Technical Service Bulletin

01 Engine Crankcase breather Whistling Noise and DTC P227900 warning light ON

01 23 79 2069351/4 September 20, 2023. Supersedes Technical Service Bulletin Group 01 number 23-59 dated June 28, 2023, for reasons listed below.

Model(s)	Year	VIN Range	Vehicle-Specific Equipment
A8	2019 – 2022	All	With 4.0L Engine
S8	2020 – 2022		
SQ7, SQ8, and RS Q8	2020 – 2023		
RS 6 Avant, and RS 7	2021 – 2023

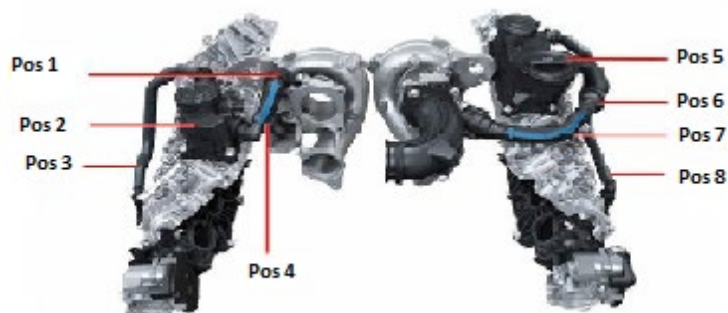
In this case, replace the full load breather line for cylinder bank 1.

1. Do not replace the oil separator for bank 1 or bank 2 or the part load breather lines.
2. Please refer to image of the crankcase breather from the Self Study Program 920493 as a guide.

Item 4: Full load breather line for bank 1 (Replacement required)

Improved crankcase full load breather line for bank 1 have been implemented in production between the end of Q2 2021 and the start of Q4 2021, depending on engine version. See table below:
